AGENDA # 5

REPORT OF: URBAN DESIGN COMMISSION	PRESENTED: July 12, 2006
TITLE: 505-550 Midvale Boulevard, Midvale Plaza Redevelopment, PUD(GDP-SIP), Mixed-Use Development. 11 th Ald. Dist. (02988)	REFERRED: REREFERRED: REPORTED BACK:
AUTHOR: Alan J. Martin, Secretary	ADOPTED: POF:
DATED: July 12, 2006	ID NUMBER:

"UDC" SET
JULY 12, 2006

Midvale Plaza Redevelopment

Midvale Elevation

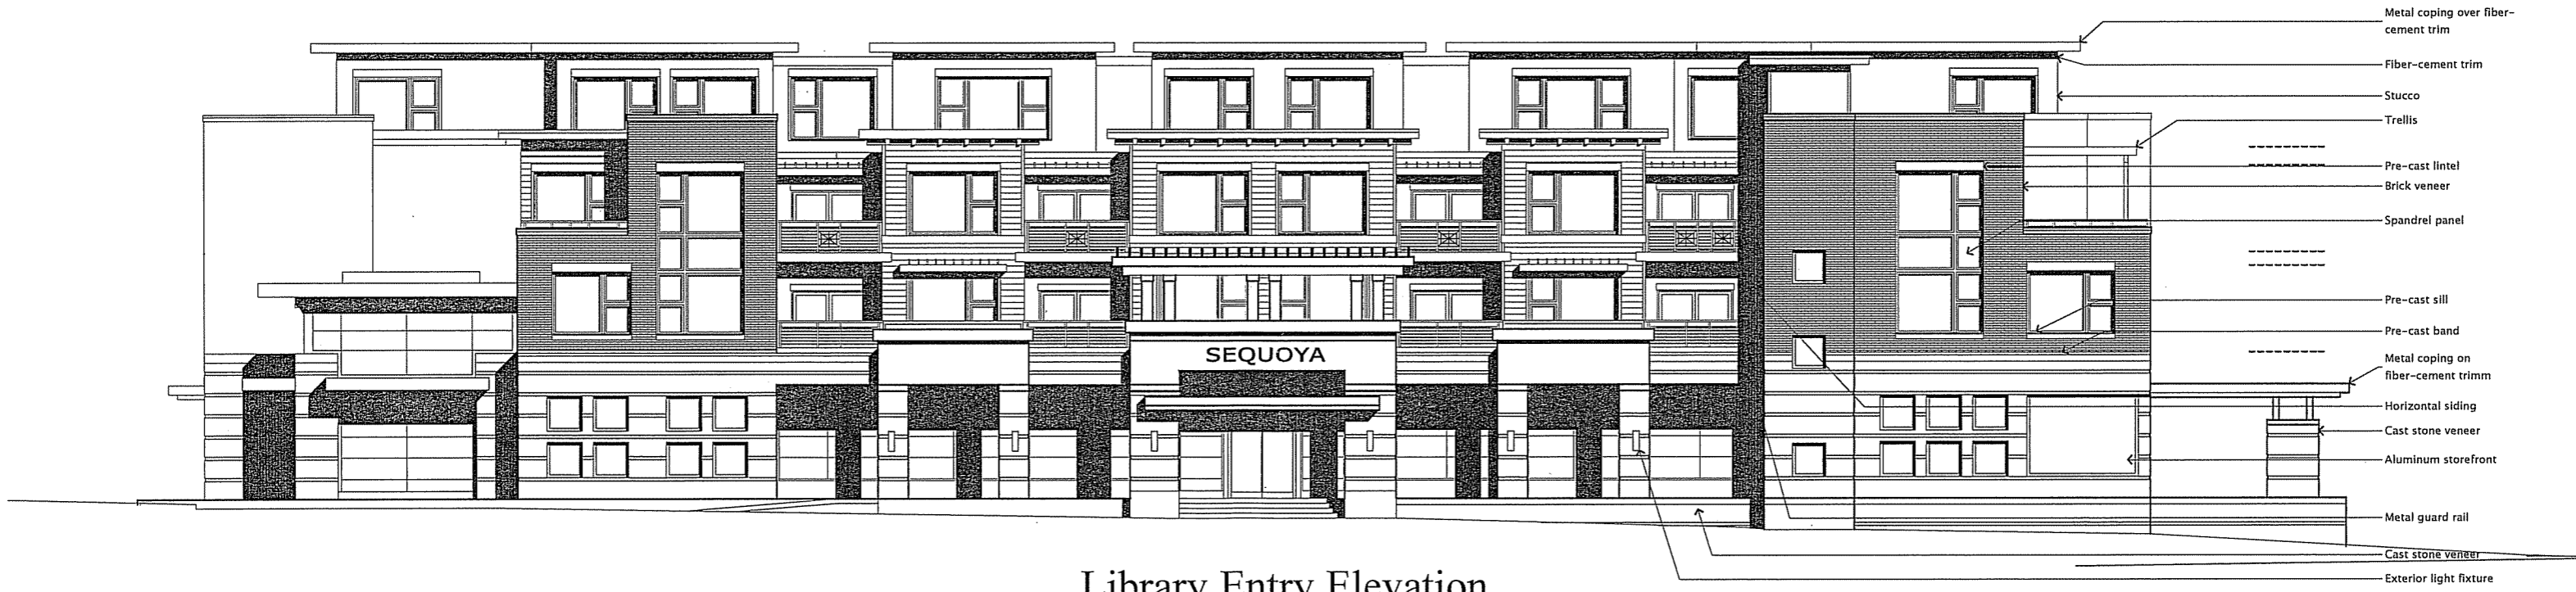
- The first floor façade of the Midvale Boulevard elevation of the library features the pronounced use of a cast stone veneer, in combination with deep set windows and covered colonnade to distinguish it from the overlying architecture of the residential component of the upper three floors that feature a variation in façade coverings that range from stucco with fiber cement trim, brick veneer and horizontal siding.

- The Midvale elevation distinguishes lower level retail with aluminum storefront elements with brick veneer, in combination with cast stone with brick veneer integrated within elements of the second and third floor areas of upper story residential units, in combination with stucco and horizontal siding.

- Like the different treatment of the Phase I building façade, especially the library portion.
- The library features identifiable architecture that ties well to upper stories.

- Simplify railings on upper story residential unit balconies with the elimination of the star emblem.
- Like the depth of window openings on the library level; adds strength to the base, but still have reservation about the lack of activation of the corner with no major use, entrance or feature.

- The lack of a corner treatment is still an issue; look at providing a pocket park at the corner or alternative feature.
- The corner treatment needs more work; should be more than a meeting area and not just a landscaped space.

Tokay Blvd. Elevation

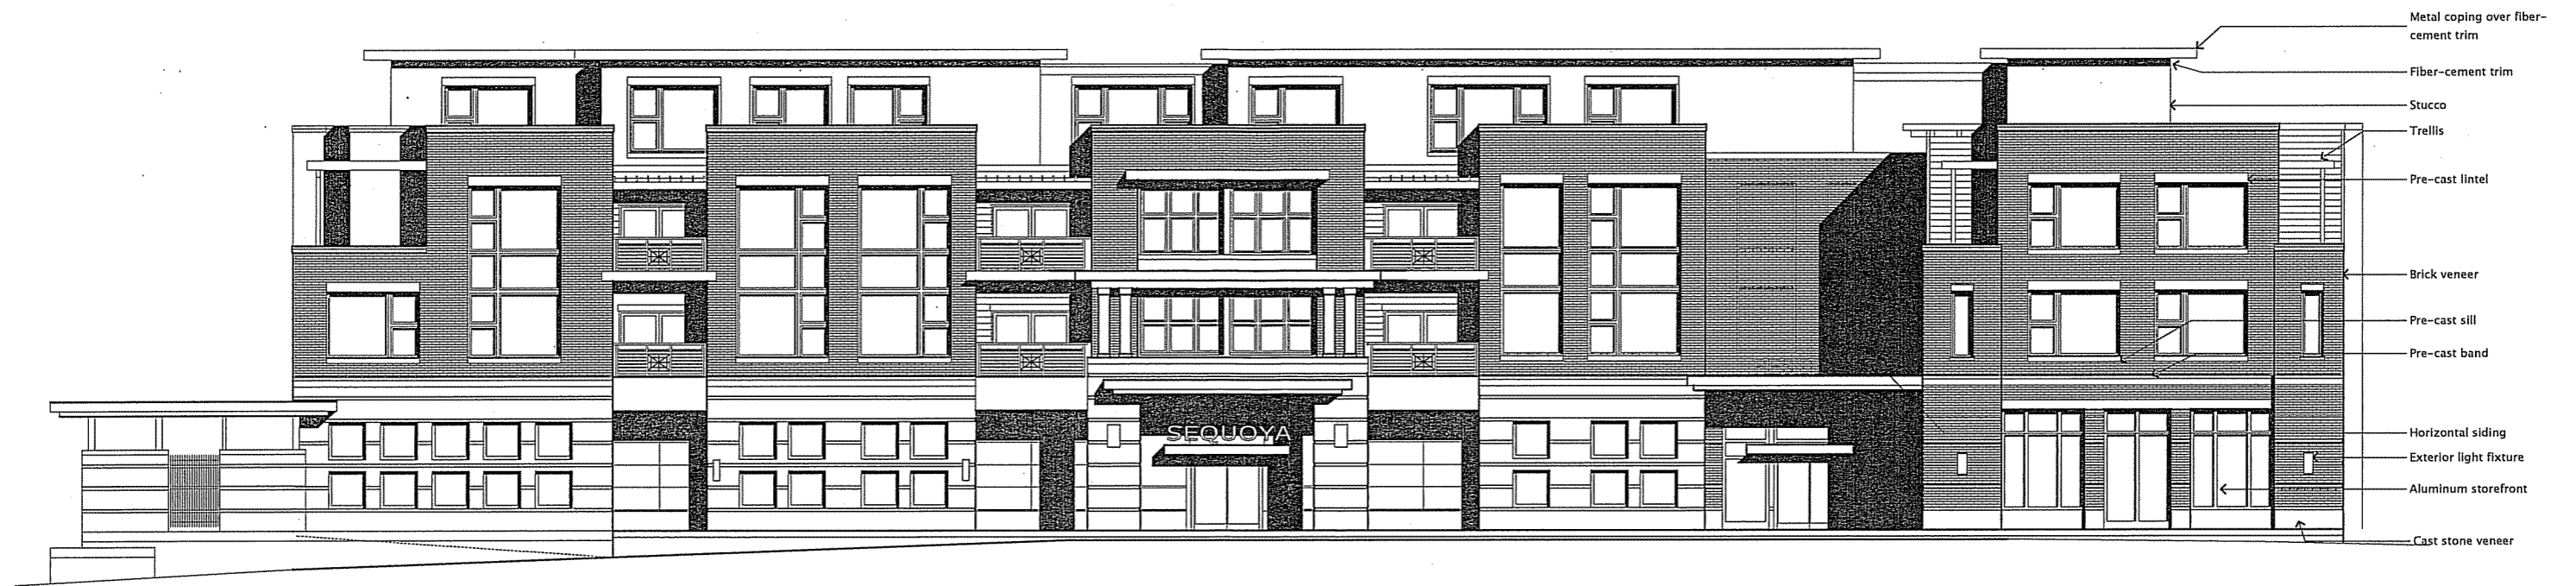
- The Tokay Boulevard elevation features the application of cast stone veneer consistent with its recognition of the library level, combined with the application of brick veneer on the second and third story levels, including portions of the first floor level containing proposed retail with the fourth level featuring the use of stucco in combination with horizontal siding.

- The Caromar Drive elevation maintains the identity of the first floor library level with the application of cast stone veneer with portions of the second and third story residential levels featuring the use of brick veneer, along with portions of the third and fourth stories utilizing horizontal siding and stucco.
- The window treatment for the library features the fenestration of windows with deep set openings; differentiated from upper story residential window treatment that incorporates the use of fixed picture windows, in combination with double hung windows.
- The conceptual material color palette will differentiate library and retail/commercial first floor façades with a distinct color for each type of use; specific colors are yet to be determined.
